Product Change Notification - SYST-14DMFW468

ERRATA - dsPIC33EPXXGS50X Family Silicon Errata and Data Sheet Clarification

- 1) Adds silicon issue 43 (PLL)
- 2) Adds data sheet clarifications 6 (High-Speed, 12-Bit Analog-to-Digital Converter (ADC)) and 7 (High-Speed, 12-Bit Analog-to-Digital Converter (ADC)).

**dsPIC33EPXXGS50X Family
Silicon Errata and Data Sheet Clarification**

FIGURE 1: EXAMPLE FOR REDUNDANT OUTPUT MODE

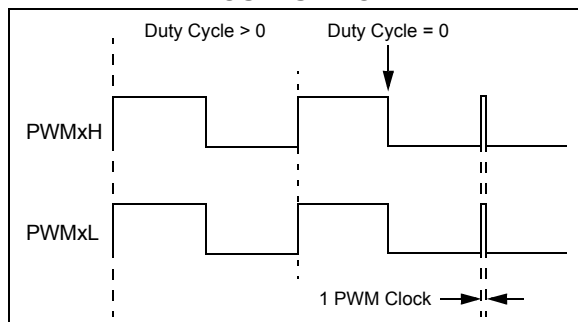
In the Redundant Output mode (IOCONx[11:10] = 0b01) and Push-Pull Output mode (IOCONx[11:10] = 0b10), with the Immediate Update Enable bit disabled (PWMCONx[0] = 0), when the Duty Cycle register is updated from a non-zero value to zero, a glitch pulse of a width equal to one PWM clock will appear at the next PWM period boundary, as shown in Figure 1 (for the Redundant Output mode). The Duty Cycle register refers to the PDCx register if PWMCONx[8] = 0 or the MDC register if PWMCONx[8] = 1.

If the application requires a zero duty cycle output, there are two possible work around methods:

1. Use the PWM override feature to override the PWM output to a low state instead of writing to the Duty Cycle register. In order to switch back to a non-zero duty cycle output, turn off the PWM override. The override-on and override-off events must be timed close to the PWM period boundary if the IOCONx register has been configured with IOCONx[0] = 0 (i.e., output overrides through the OVDDAT[1:0] bits occur on the next CPU clock boundary).
2. Enable the Immediate Update Enable bit (PWMCONx[0] = 1) while configuring the PWMx module (i.e., before enabling the PWMx module, PTCON[15] = 1). With the Immediate Update enabled, writes to the Duty Cycle register can have an immediate effect on the PWM output. Therefore, the duty cycle write operations must be timed close to the PWM period boundary in order to avoid distortions in the PWM output.

FIGURE 2:

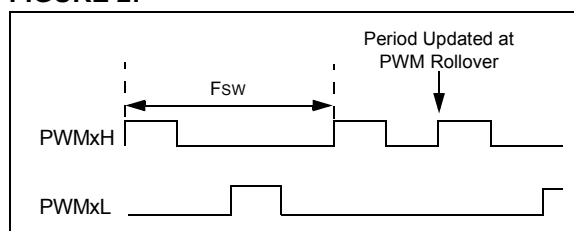
When the PWM module is configured for Push-Pull mode (IOCONx[11:10] = 0b10) with the Enable Immediate Period Update bit enabled (PTCON [10] = 1), a write to the Period register that coincides with the period rollover event may cause the push-pull output logic to produce back-to-back pulses on the PWMx pins (Figure 2).

Ensure that the update to the PWM Period register occurs away from the PWM rollover event by setting the EIPU bit (PTCON[10] = 1). Use either the PWM Special Event Trigger (SEVTCMP) or the PWM Primary Trigger (TRIGx) to generate a PWM Interrupt Service Routine (ISR) near the start of the PWM cycle. This ISR will ensure that period writes do not occur near the PWM period rollover event.

FIGURE 3: MISMATCH OF WORKING REGISTER SET WHEN NESTING MORE THAN ONE INTERRUPT WITHIN INTERRUPTS THAT USE ALTERNATE WORKING REGISTER SETS

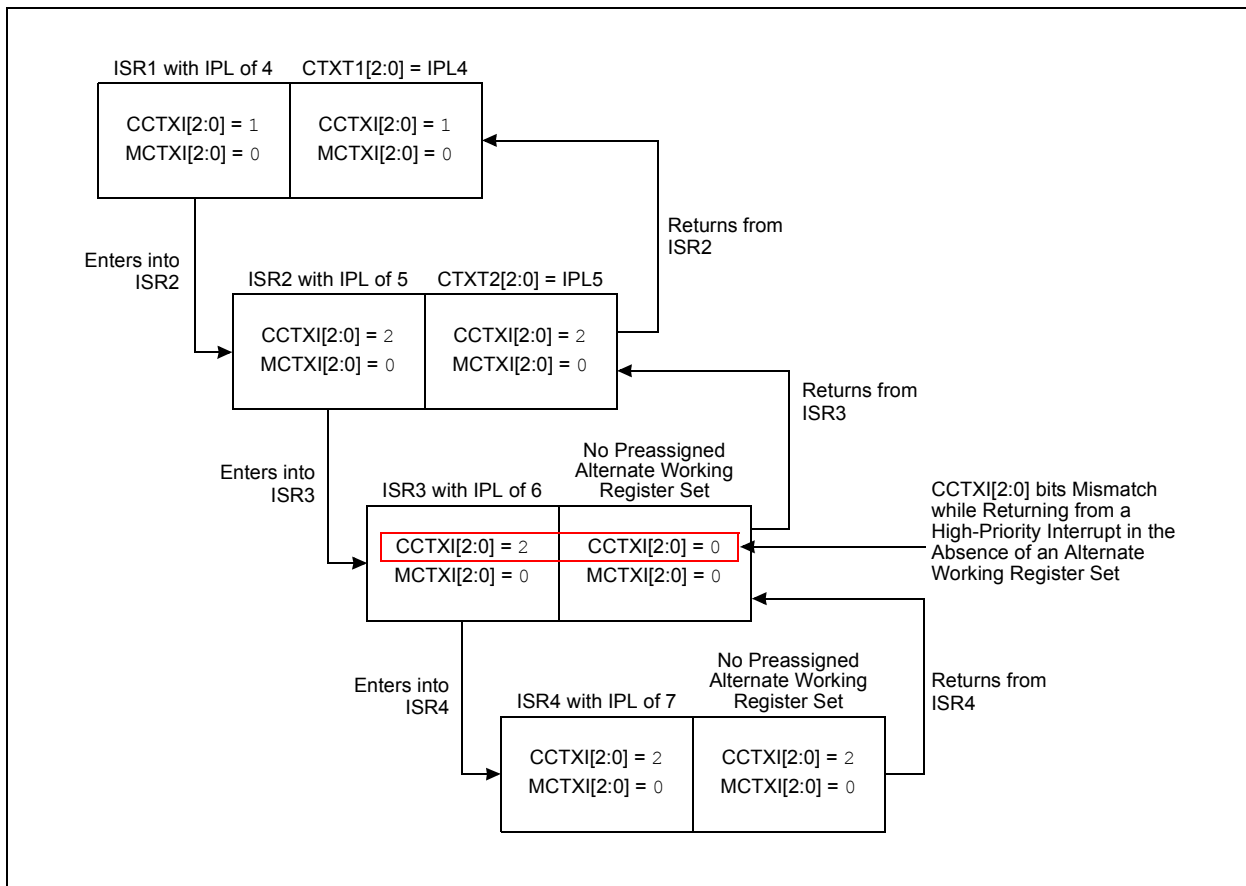
When using interrupts with the Alternate Working Register Set (automatic context assignment), no more than one ISR without an Alternate Working Register Set must be nested within an ISR with an Alternate Working Register Set.

Issue and work around are illustrated in [Figure 3](#) and [Figure 4](#), respectively. The figures show the status bits, `CCTXI[2:0]` and `MCTXI[2:0]`, after entering into an ISR from a lower priority ISR (left pane), and after returning to the same ISR from a higher priority ISR (right pane).

FIGURE 5: SIMPLIFIED BEHAVIOR

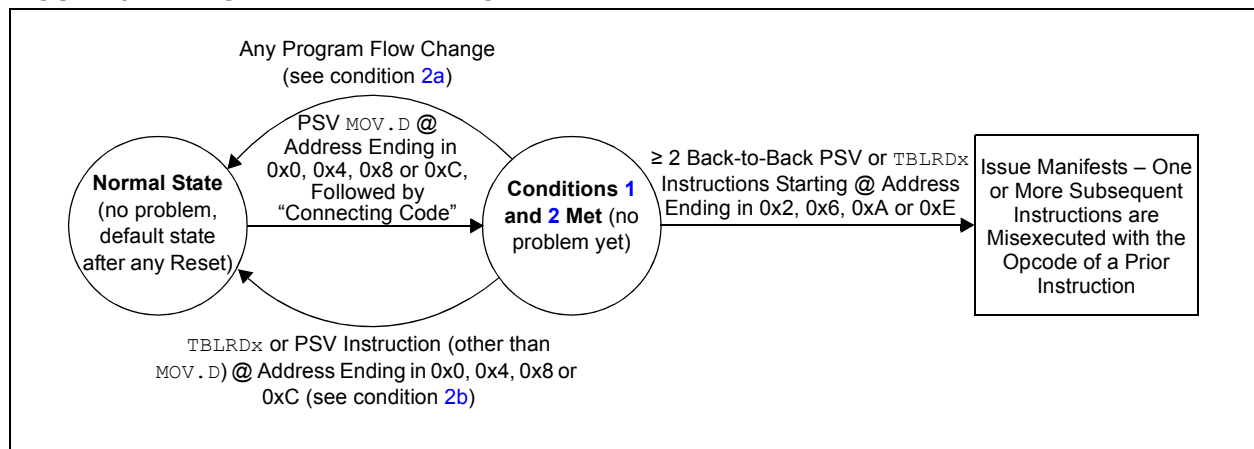
3. ≥ 2 back-to-back PSV or <code>TBLRDx</code> instructions are executed (following the code of condition 2), where the first of the back-to-back instructions is located at an address ending in 0x2, 0x6, 0xA or 0xE.

[Figure 5](#) provides an example of the effective behavior.

1. All instances of PSV `MOV.D` can be replaced with two PSV `MOV` instructions instead. Non-PSV `MOV.D` instructions acting on RAM/SFRs do not need to be modified; or
2. If not already present, a program flow change instruction (such as `BRA $+2`) can be inserted above back-to-back data Flash read sequences; or
3. Back-to-back data Flash read instruction sequences can be broken up by inserting a non-Flash read instruction (such as a `NOP`), in between the Flash read instructions; or
4. The alignment of the code can be shifted to avoid the required opcode location addresses.
